**ADDENDUM TO THE  
ENVIRONMENTAL IMPACT  
ASSESSMENT REPORT OF  
LIGHT RAIL TRANSIT PROJECT  
(JICA)**

**Submitted by  
Project Management Unit  
Light Rail Transit Project  
Ministry of Megapolis and Western Development**

**18<sup>th</sup> July 2018**

Figure 3.3

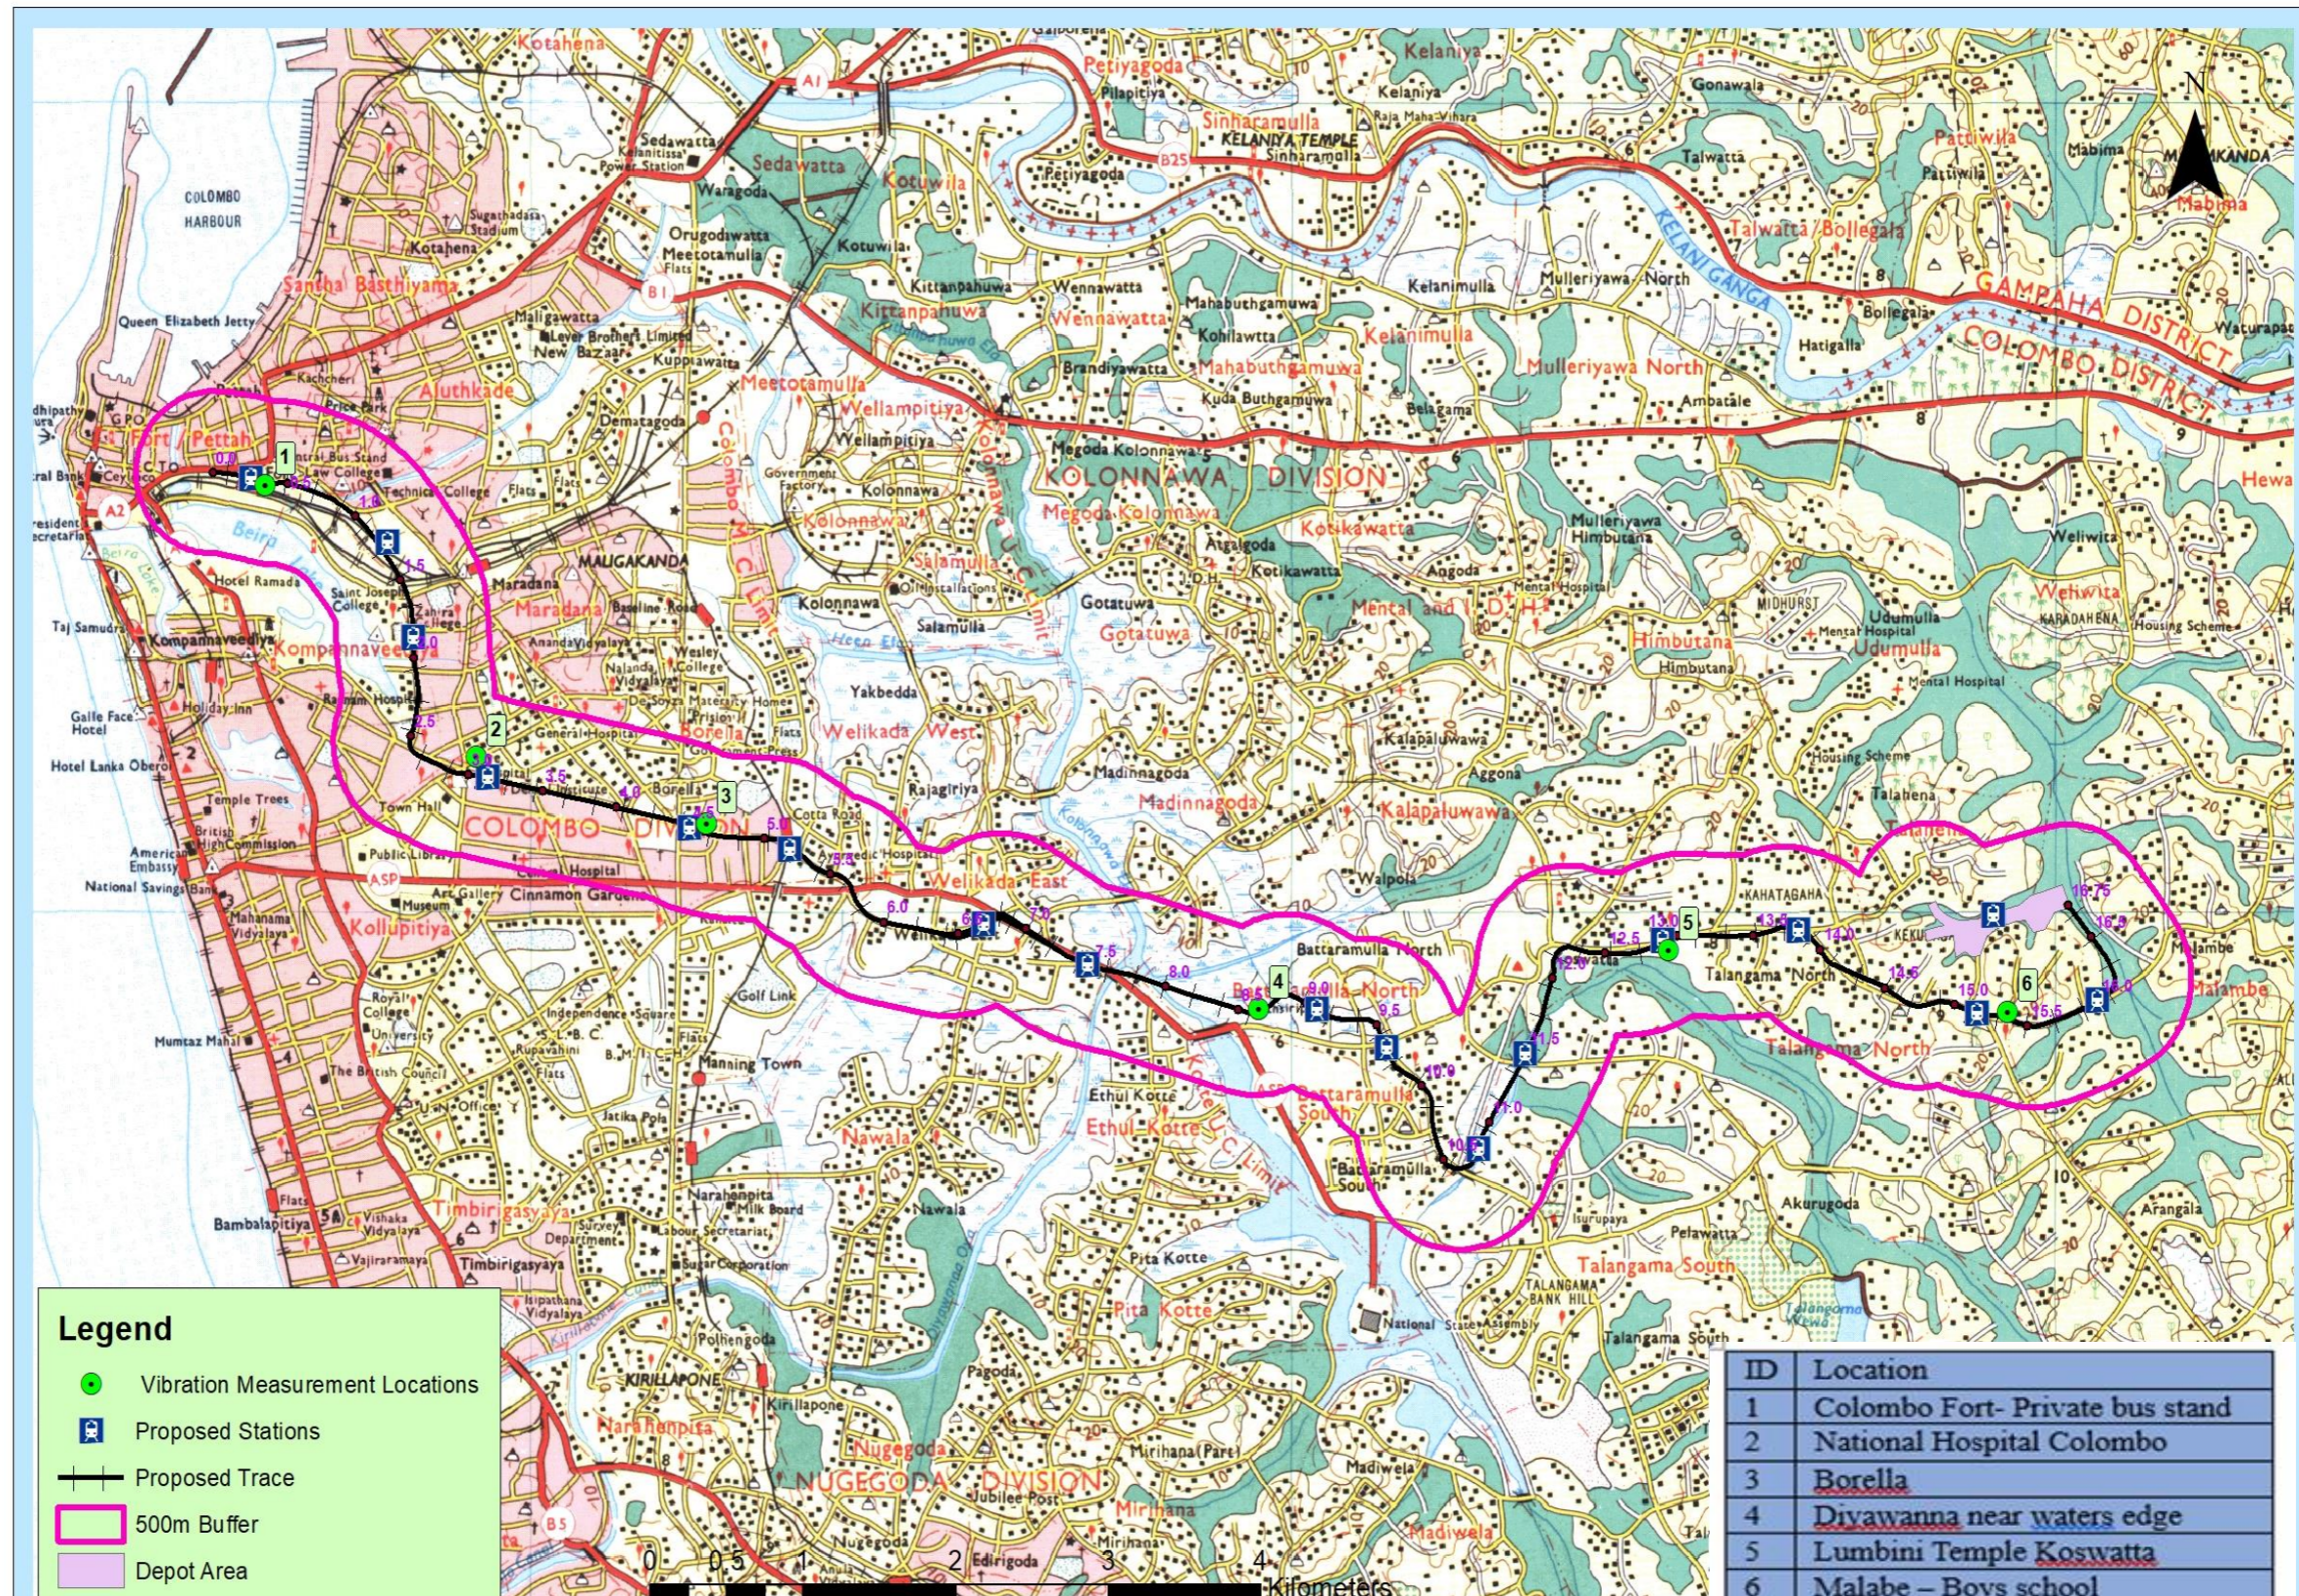
3	Locations where vibration levels are measured need to be defined and they are defined only with numerals without clear reference	Table 3.5 and Figure 3.3 was modified with the locations	Table 3.5 and Figure 3.3 in Addendum of EIA Report
4	At some points, the predicted construction noise levels even with barriers exceed the permissible noise (75dB) and thus, there is high tendency to exceed the standards during both daytime and night time	It has been further described in Chapter 4.1.1 by introducing appropriate materials to be used for noise barriers and for the points exceeding the noise levels, it is also considered to change the material type and height of the noise barriers.	Chapter 4.1.1, Table 4.2 and 4.2A in the Addendum of EIA Report
5	Under the sub section 4.1.1 (page 4-3) stated as "with the use of noise barriers fence (3m height), noise level can be reduced by up to 10dB". However, the implementation may be difficult considering the practical situation. EIA preparers need to give more specific elaborations with the conceptual designs as to how this noise reduction be achieved.	It was elaborated in Table 4.2A and through a conceptual design given for Type 1 and Type 2 noise barriers.	Table 4.2A of Addendum of EIA Report

**Figure 4.1 A Conceptual design of noise barrier**

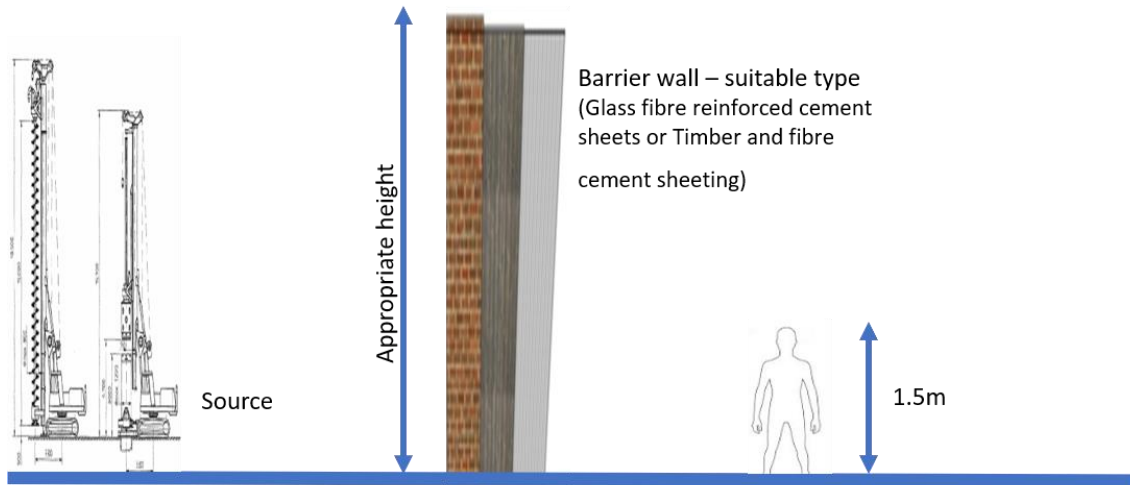
Two types of noise barriers are suggested i.e. Type 1 and Type 2. Details of the height and the types of material included in these barriers are as follows.;

Noise Barrier Type	Height	Material Types used for Sound Insulation	Remarks
Type 1	3m	Timber and fibre cement sheeting.	Can reduce 5-10dB
Type 2	>3m	Glass fibre reinforced cement sheets	Can reduce at-least 15dB by adjusting the height and the material type
